Value Engineering Study
Us60 RECONSTRUCTION
BALLARD & MCCRACKEN COUNTIES, KY

ITEM NUMBERS 1-115.00 & 1-115.10
VE STUDY NUMBER 201109

Final Report

December 22, 2011

Sketch of Recommended Approximated Tangents for Vertical Curves at Westerly End of Item No. 1-115.00

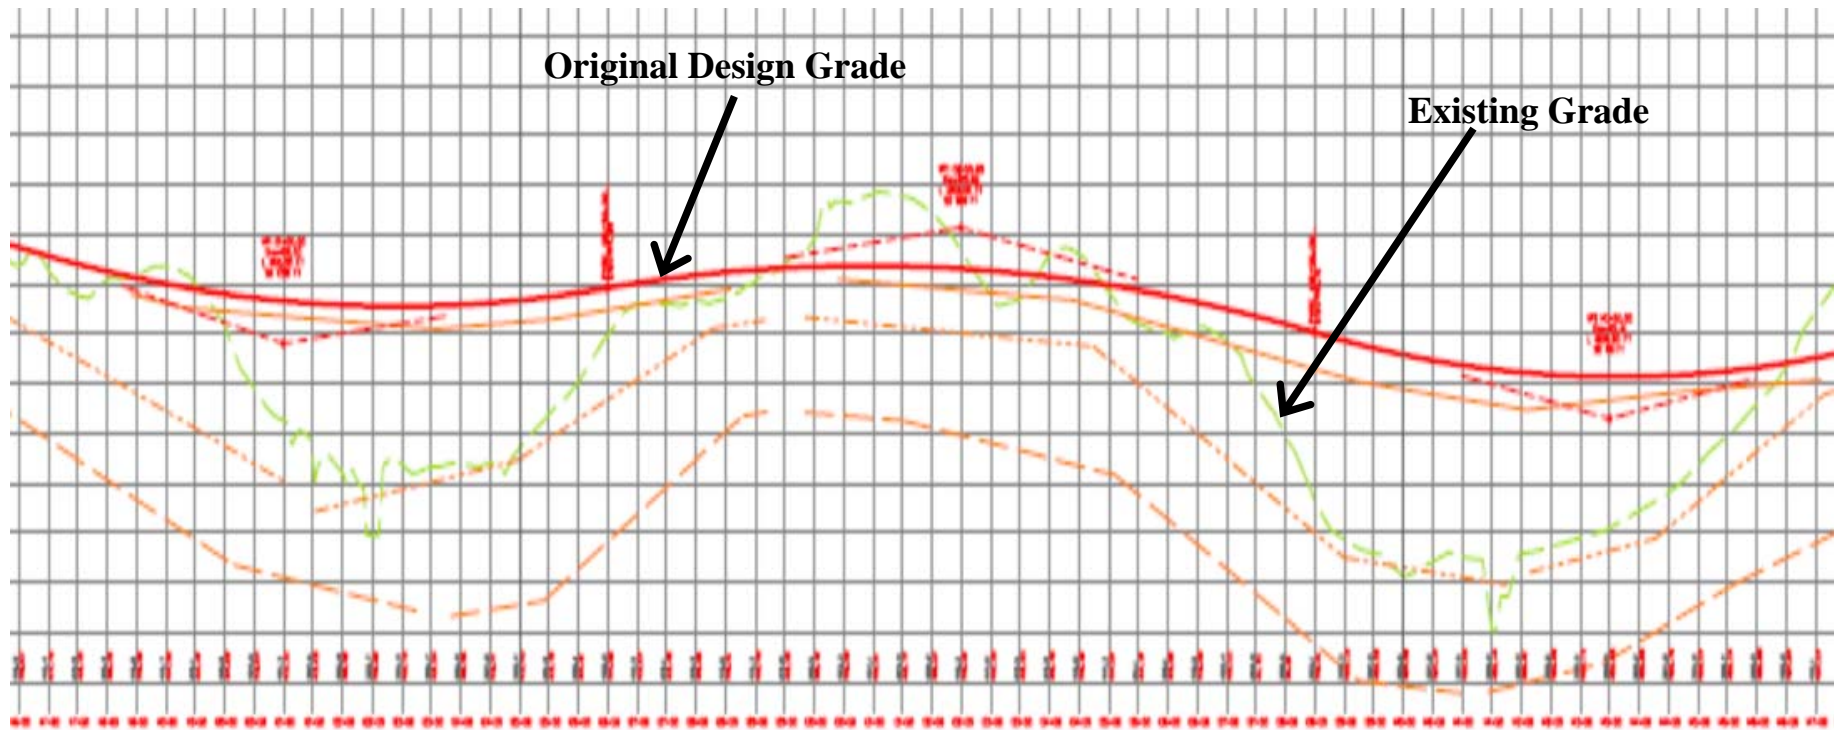
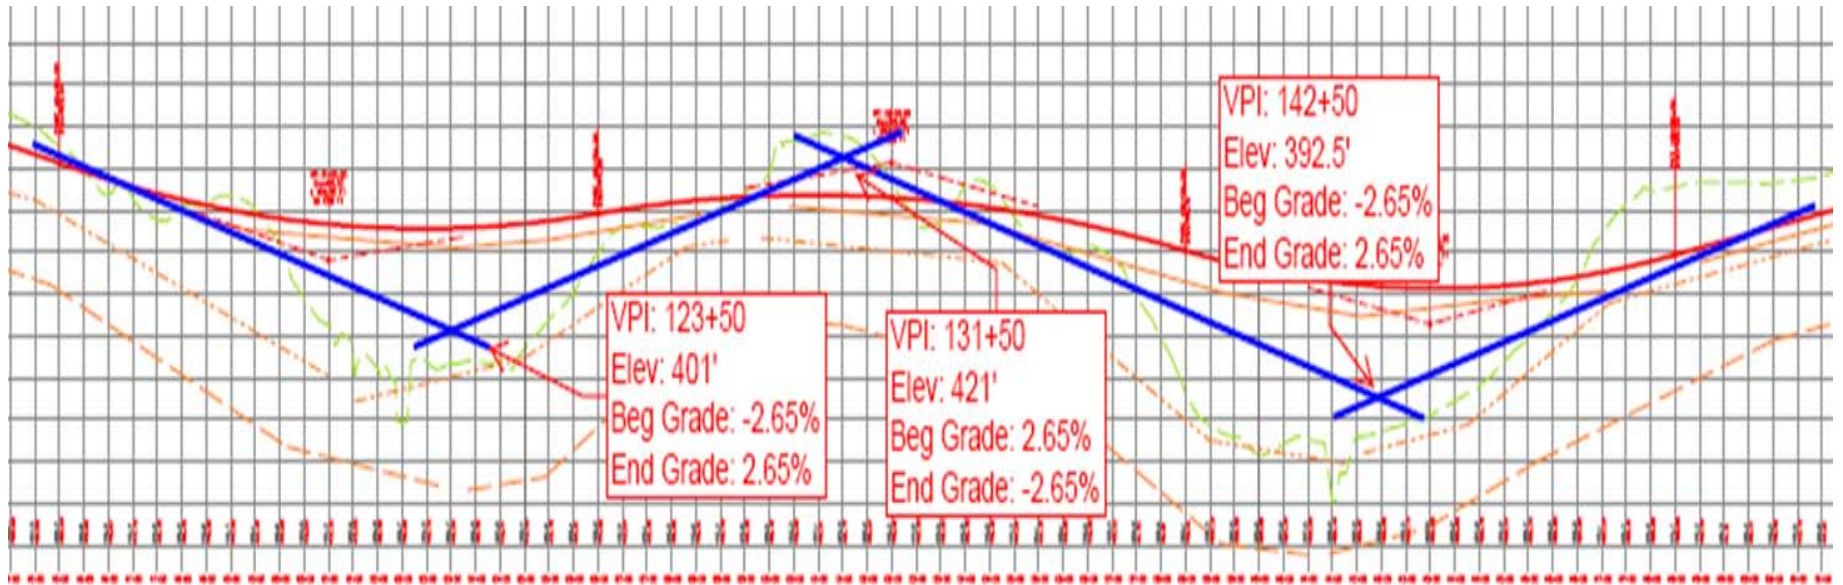
The VE Team recommends using maximum allowable grade and minimum allowable sight distance to reduce the embankment depth at the locations listed above. The maximum allowable grade of 2.65% is identified in the Item No. 1-115.00 Design Executive Summary shown in the figure below. The minimum allowable sight distance of 570 ft (K=151) is shown in Exhibit 3-76 of the AASHTO-Geometric Design of Highways and Streets that is subsequently included.

The embankment depths were reduced by using the maximum grade of 2.65% and the minimum allowable sight distance of 570 ft. An example road profile revision is shown in the attached drawing, vertical curve tables, and road elevation comparison table. These vertical curve and road elevation revisions were roughly applied to Item No. 1-115.00 Stations 117+00 to 150+00. Another option within these stations that was not explored is to lower the elevation of the hill between the two low areas (and therefore the point of intersection of Sullivan Lane) in order to eliminate the down/up/down profile that is part of the attached example.

Typical road design practice aims to provide a safe and cost effective road by balancing items such as profile, earthwork, drainage, and clear zones for slopes and stationary objects. AASHTO establishes minimum criteria for safe road operations for some of these items. On this project, the Design Team has opted to apply more stringent criteria than AASHTO will allow. This is the case with maximum allowable grade and stopping sight distance criteria. The VE Team agrees that this relatively flat project site does not justify the AASHTO maximum allowable grade of 4% and agree that the 2.65% chosen by the Design Team is reasonable. However, the stopping sight distance increase from 570 ft to 914.22 ft may not be reasonable. In addition, the VE Team notes that the current design does not even apply the maximum allowable grade and remains substantially beneath 2.65% in most cases.

Sketch of Existing US60 17+00 and US60 122+50 Culvert Modification and Stream Relocation at the West End of Item No. 1-115.00

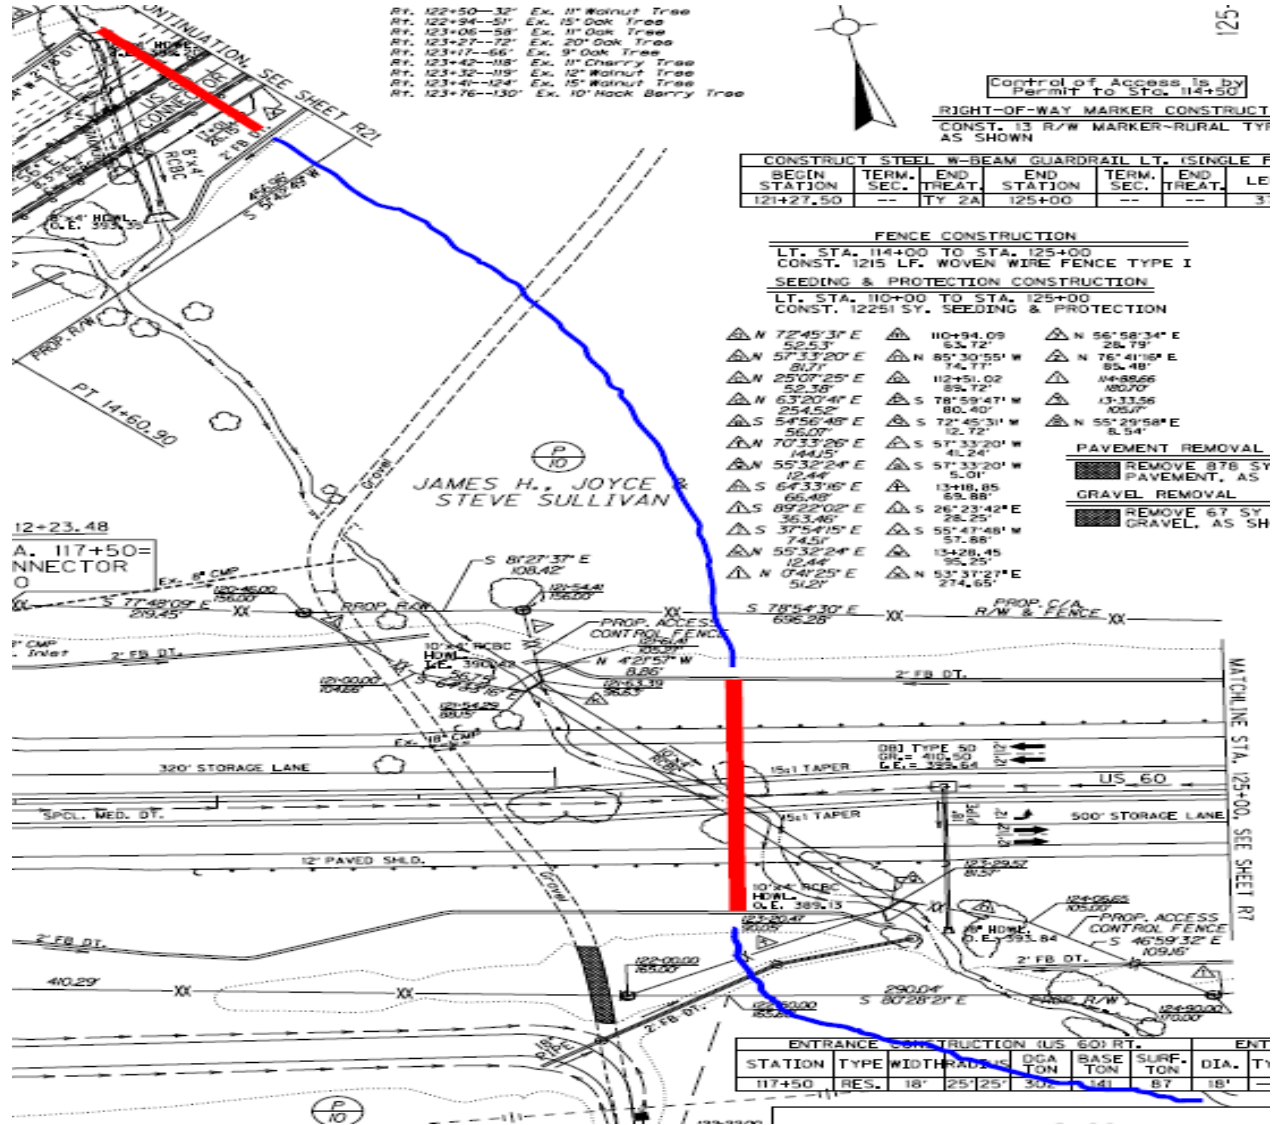
The VE Team was asked to review this change. The team believes that the following benefits can be derived from this change at each culvert as follows:

Existing US60 Station 17+00 – Revised box culvert location fits from ditch bottom to ditch bottom with 4:1 slopes. This allows for elimination of guardrail as long as the ends of the culvert are outside the clear zone.

US60 Station 122+50 – Revised box culvert location still requires 2:1 slopes and therefore guardrail. If the profile is lowered and the embankment is reduced, the potential exists to use the barn roof section at this location and eliminate guardrail as well.

Recommended Design: 2 lanes undivided roadway

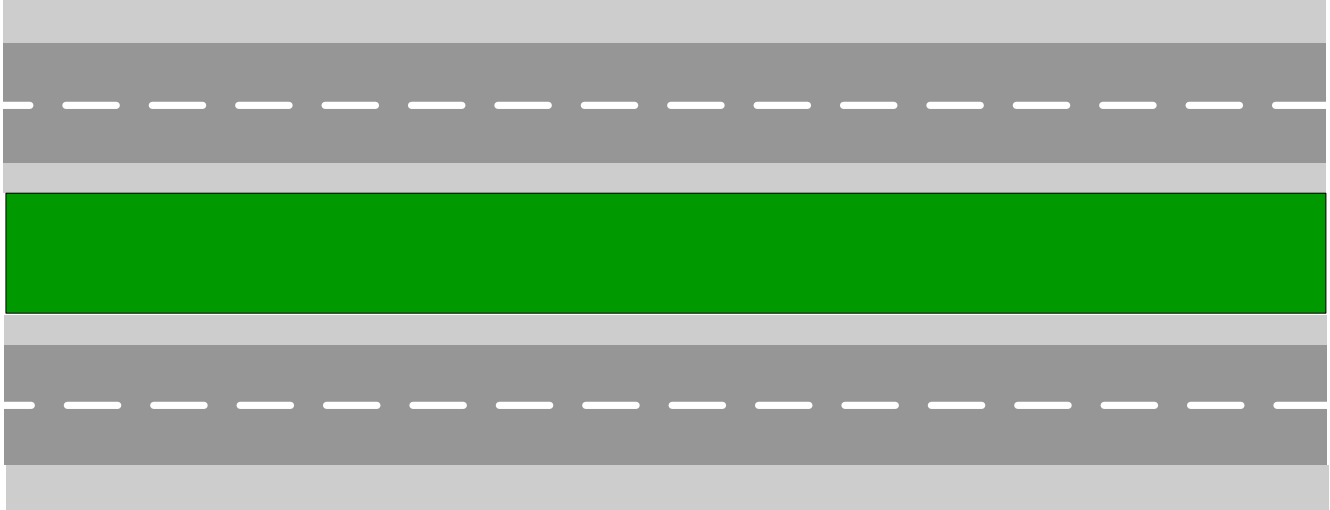
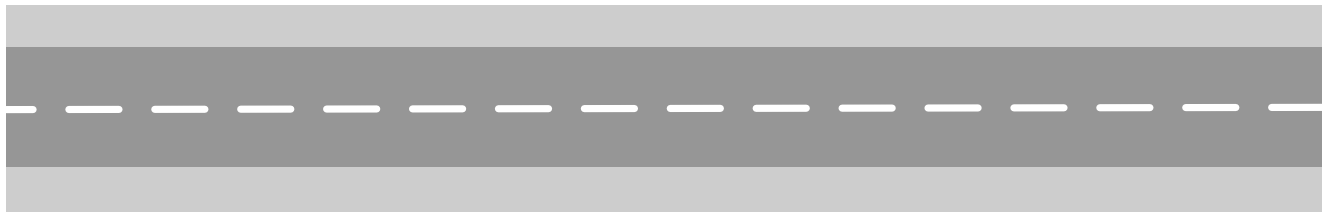
The traffic forecast was done in 2003 on based volumes from 2002. The current traffic counts in this area show that volumes have remained stable with very low growth. For example, the traffic count in 2011 just west of Wren Road was 8,104 vehicles per day (VPD) and the 2002 base count was 8,300 VPD. In addition, the forecasts show that the peak ADT for this roadway to be only 13,620 VPD. The current counts and the forecast only demonstrate a need for a two-lane roadway.

Recommended Design: 2+1 Roadway Configuration

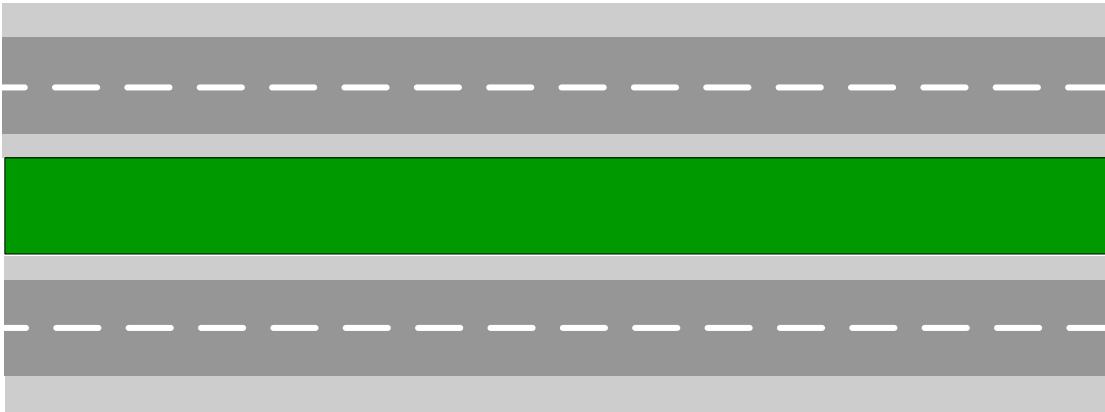
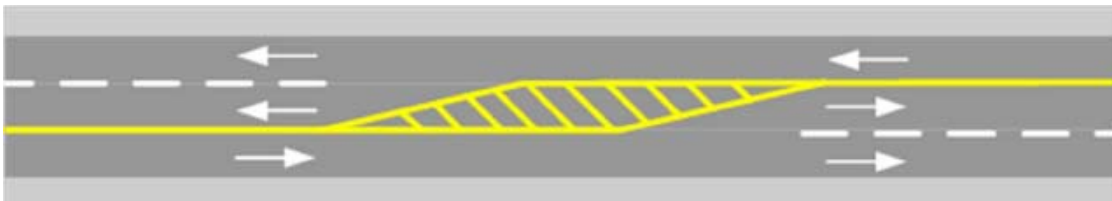
The traffic forecast was done in 2003 on based volumes from 2002. The current traffic counts in this area show that volumes have remained stable with very low growth. For example, the traffic count in 2011 just west of Wren Road was 8,104 VPD and the 2002 base count was 8,300 VPD. In addition, the forecasts show that the peak ADT for this roadway to be only 13,620 VPD. The current counts and the forecast only demonstrate a need for a two-lane roadway.

The original design addresses ATS by designing to have a 60 mph design speed. The current roadway generally has good geometry so not much will change with ATS. On the other hand, a new two-lane design, the grades and sight distance of the original design will allow for drivers to pass using the lane in the opposite direction when adequate gaps in traffic exist. A driver may get caught driving behind a slow moving vehicle and feel uncomfortable passing even when a passing opportunity exists. The 2+1 alternate gives alternating safe locations, every one to two miles, for drivers to pass, therefore greatly improving the PTSF over the current conditions. This may be especially important when a queue of vehicles occurs behind a slow vehicle traveling such as a tractor trailer or a farm vehicle.

Examples of potential modifications to access management design

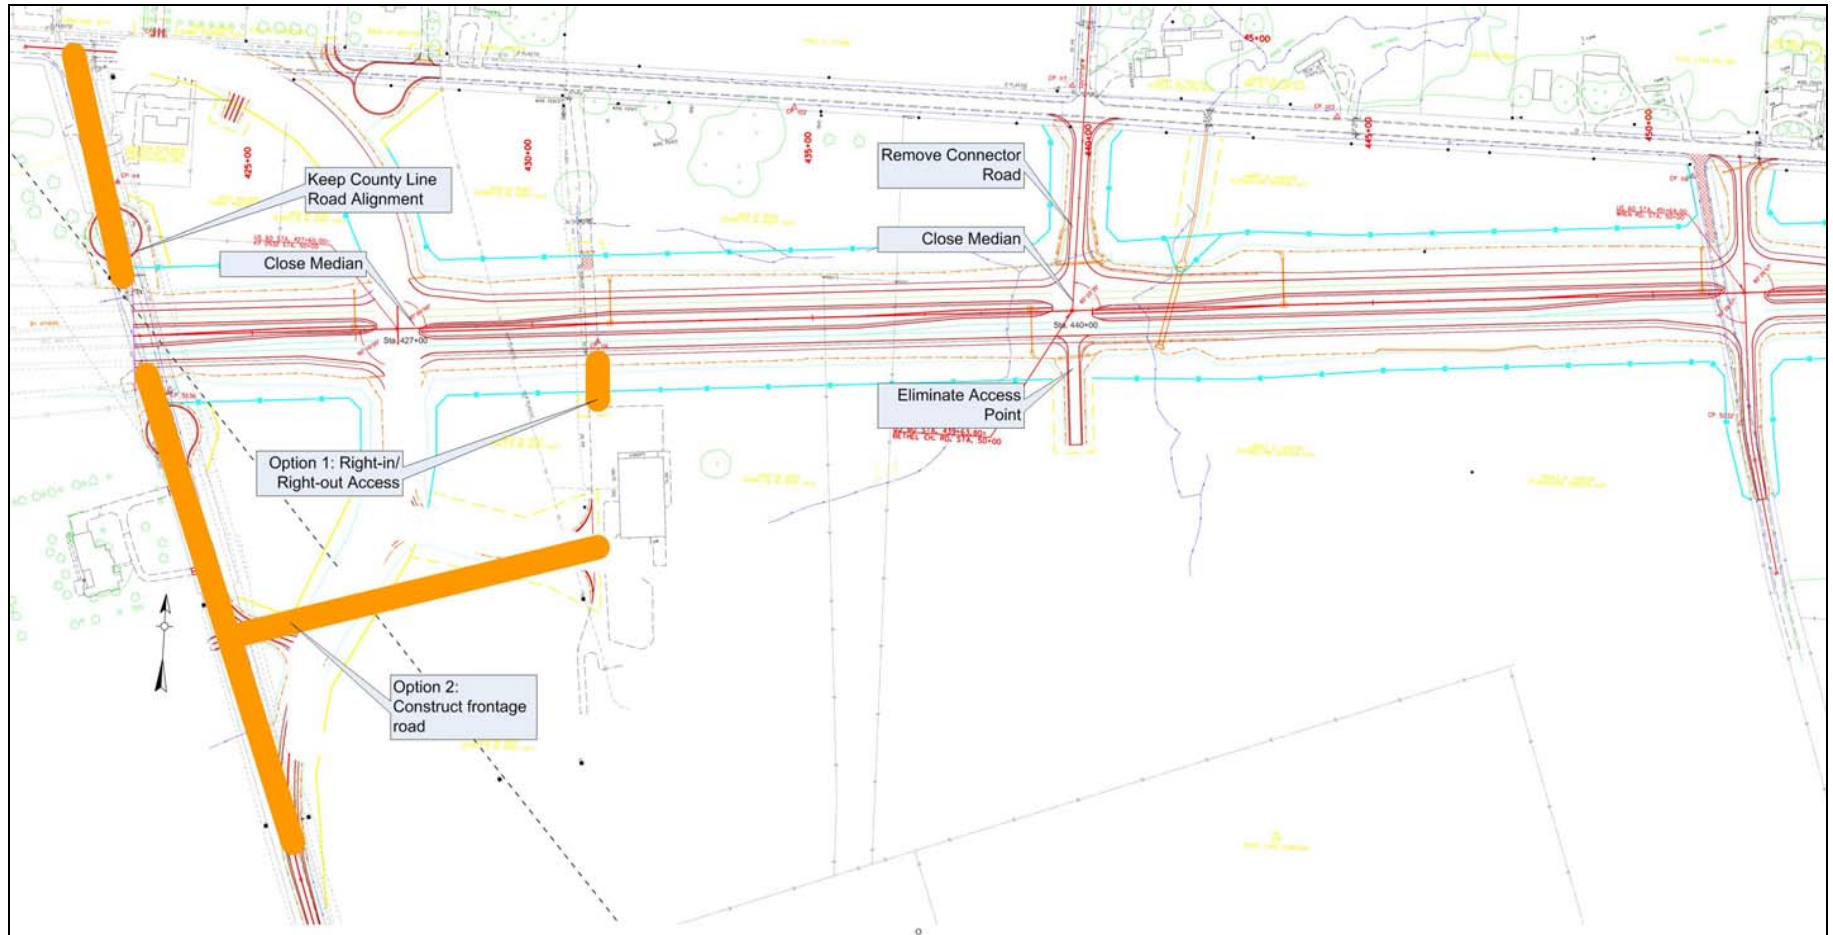
Reducing and separating the number of conflict points is a proven method to reduce the number of locations with the potential for crashes. The current design uses an access control scheme based on 1,200 foot spacing of entrances and median openings. There are several locations along the project (both Item Nos.) where the design could be modified to remove access, remove a frontage road, or close a median opening. Finding opportunities to minimize conflict points will be important for the long term viability of creating and maintaining efficient, long-distance travel through this corridor. There are also some opportunities to provide direct access to the new roadway that would save cost on creating a frontage road with little impact to operations and safety.

| B. | 164+00 | Close median opening; remove realignment of Pine Lane and make right-in/right-out; Pine Lane also has access on existing US60. |
| H. | 467+00 | Remove frontage road on the south side. Create right-in/right-out. This would be a way to save cost with little effect on traffic operations. |
| I. | 490+50 | On the north side, remove the frontage road and make the property right-in/right out with no median opening. |

Examples of Recommended Offset Left Turn Lanes

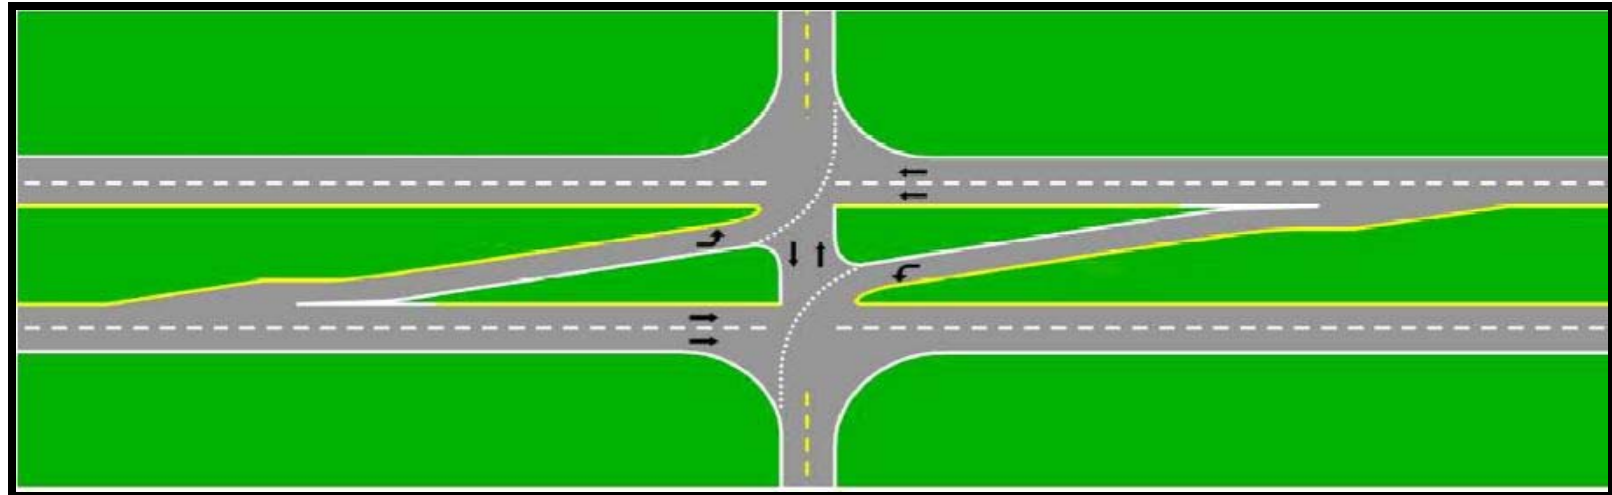
The original design includes left turn lanes at the median opening which are immediately adjacent to the travel way. Recent research has shown that offsetting the left turn lane can provide safety benefits due to improved sight distance. The basis for this is vehicles in the left turn lane at an at-grade intersection can block the view of left-turning vehicles from the opposite direction. The offset turn lane adjusts the alignment of vehicles making left turns from the highway so motorists can better see the vehicles around them, thereby making a safer left turn. Included below are some illustrations which help to visualize this concept.
